# Product Change Notification (PCN)

Part Number: 50515109\*\*, 50515110\*\* (2.0W/B REC HSG)

Part Number: 50515109\*\*, 50515110\*\* (2.0W/B REC HSG)

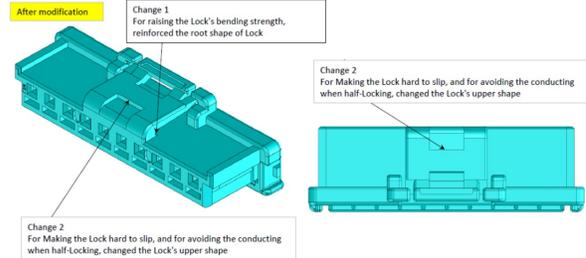
Change description: Lock's shape change to update inertia-locking mechanism
